Entrust Fashions Ltd.

25th October 2018

Observations

Change of roof bracing location

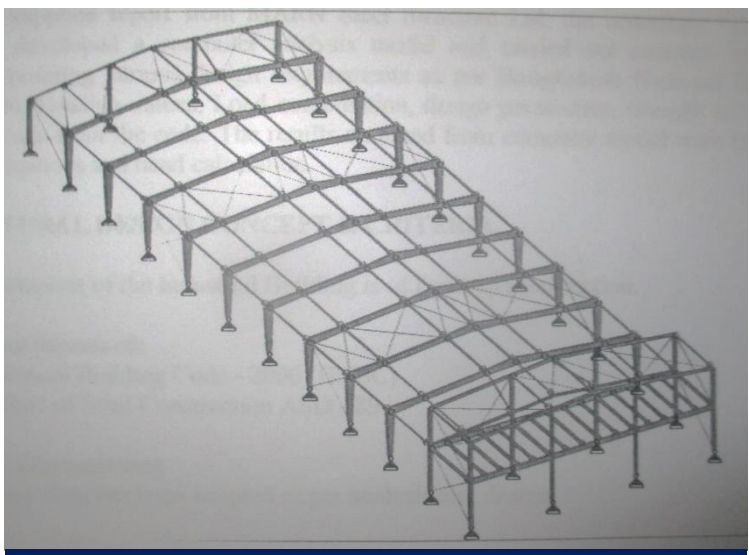
Onsite roof bracing location did not match with drawing

Vertical and roof bracing layout did not match with drawing and FEM model. Factory is required to revise the bracing layout in as-built drawing and FEM model accordingly.

Bracing Layout in structural drawing

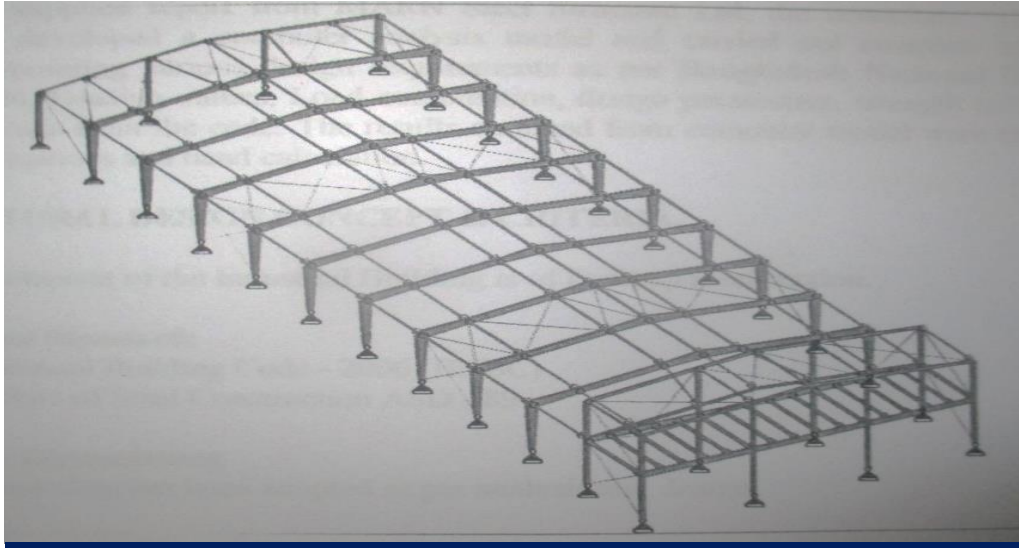
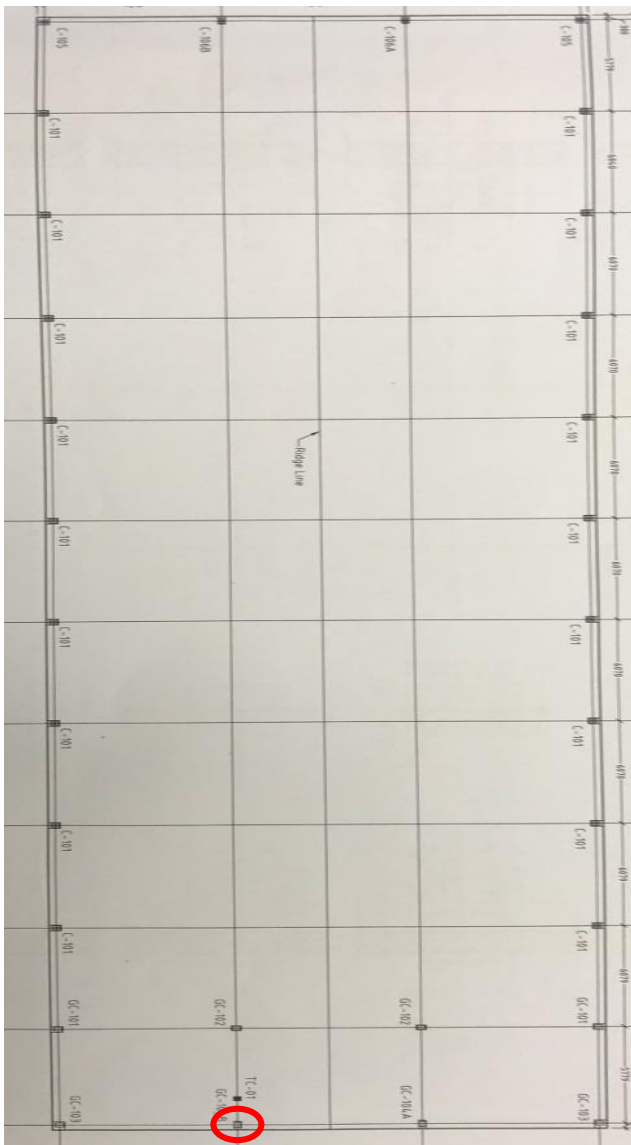
Vertical bracing not found according to the drawing

Section of Grid-12 in drawing

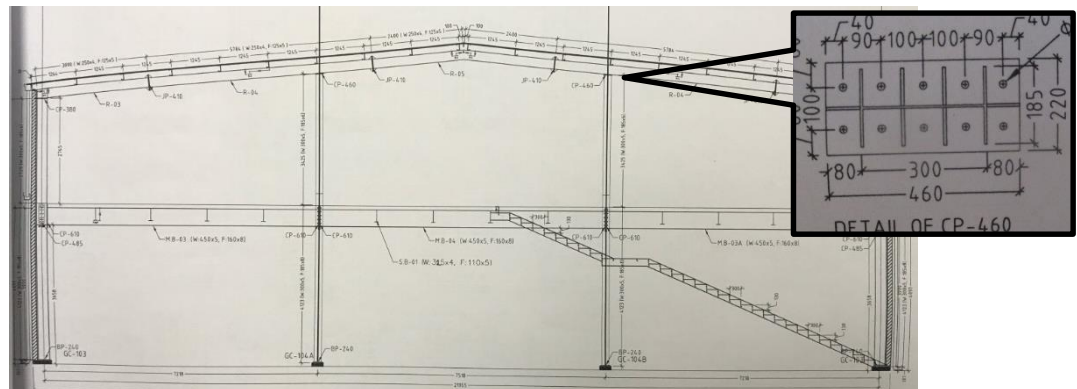
Connection of column and rafter was found different than drawing

10nos. Bolt was shown at column-rafter joint in grid 12-D whereas 8nos bolt was found on site. The connection is required to revise in drawing according to the on site condition

Significant gaps in connection

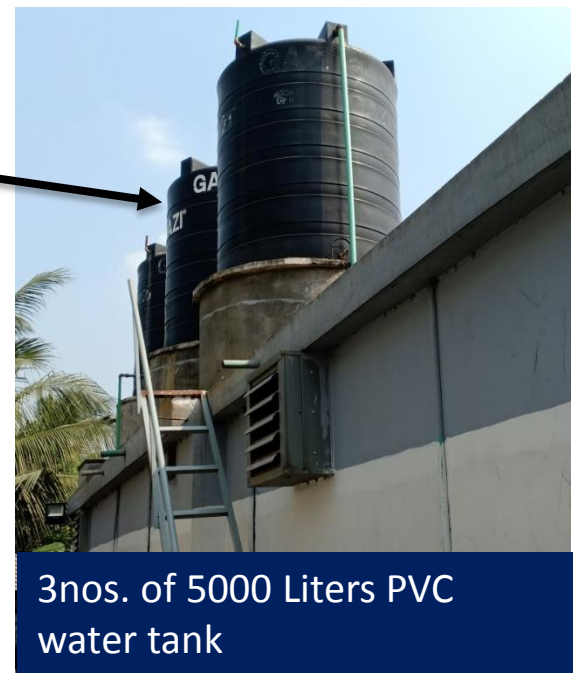
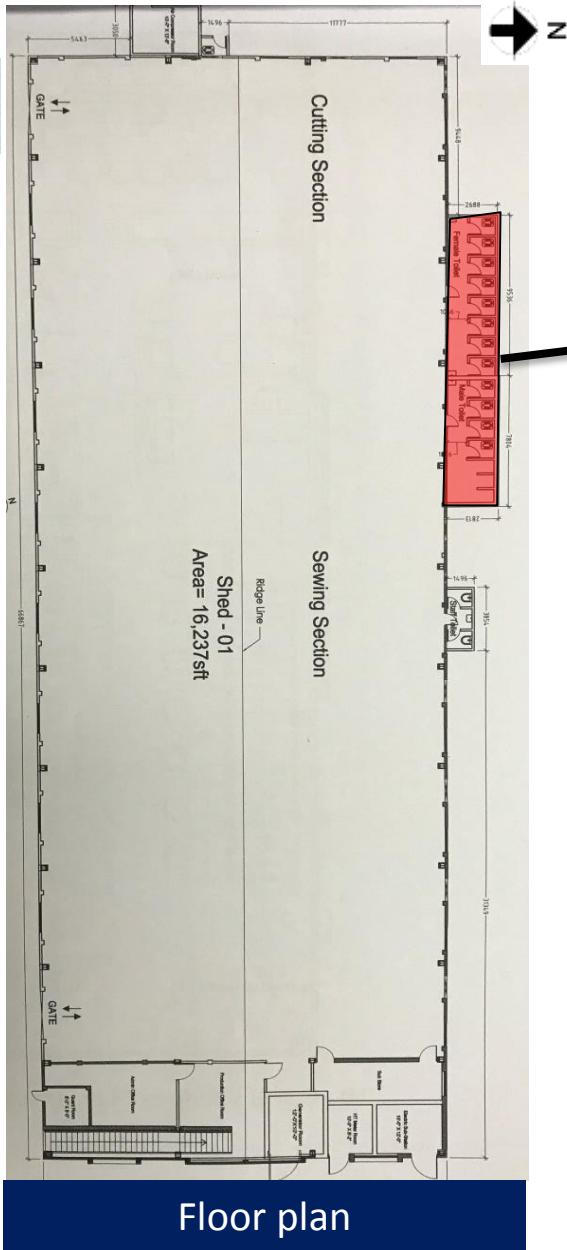
Gap was found in column-beam joint at stair case location

Significant gaps were found in column-beam joint. Factory engineer is required to carry out suitable remedial works.

Gap was found in column-beam joint at mezzanine floor

Roof bracing Layout in structural drawing

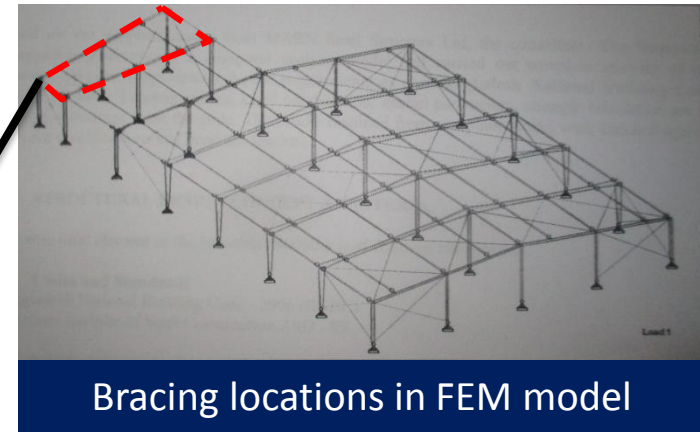
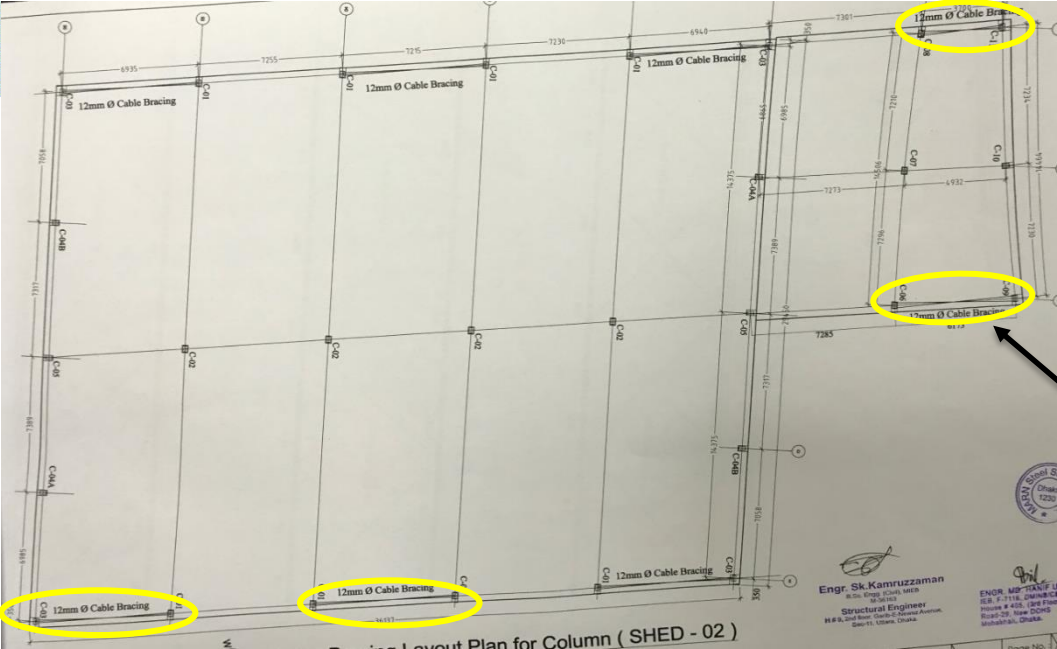
Roof bracing not found in the marked location

Vertical and roof bracing layout did not match with drawing and FEM model. Factory is required to justify the bracing requirement and install accordingly.

Vertical bracing Layout in structural drawing

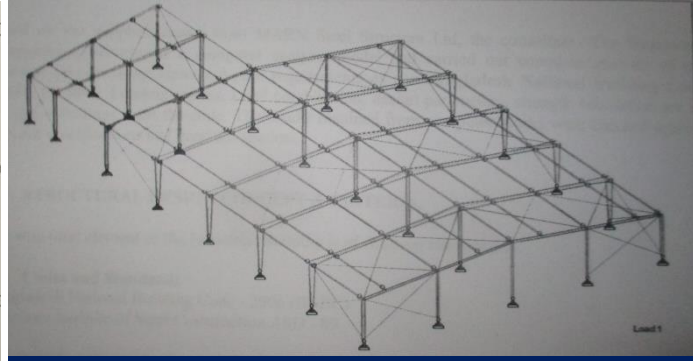
Vertical bracing not found in the marked location
